FEDERAL ENERGY REGULATORY COMMISSION
Office of Energy Projects
Division of Dam Safety and Inspections – New York Regional Office
Telephone No. (212) 273-5900

RE: Letter to Constellation Energy Generation regarding the 2025 Inspection of the Conowingo Project under P-405

P-405-MD, Conowingo
2025 Dam Safety Inspection

Photo 10 – Ponded water by the Unit 4 controls in the powerhouse inspection tunnel

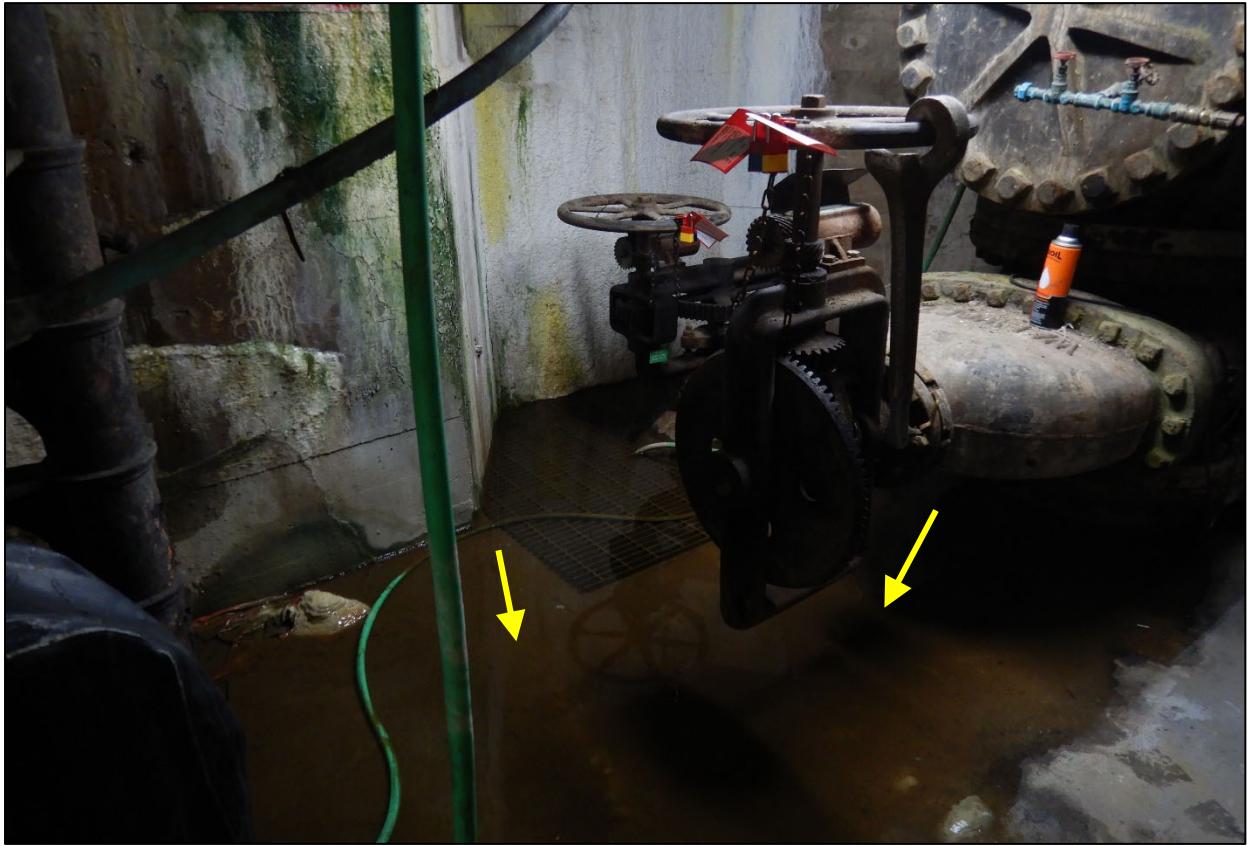
8. Ponded water was noted on the floor of the Elevation 65 powerhouse inspection tunnel, in the vicinity of Units 2 and 4 controls (Photos 10 and 11). Please investigate the cause of these conditions and remediate the leakage/flooding. In the meantime, please continue to monitor the areas and ensure that it is not developing further.
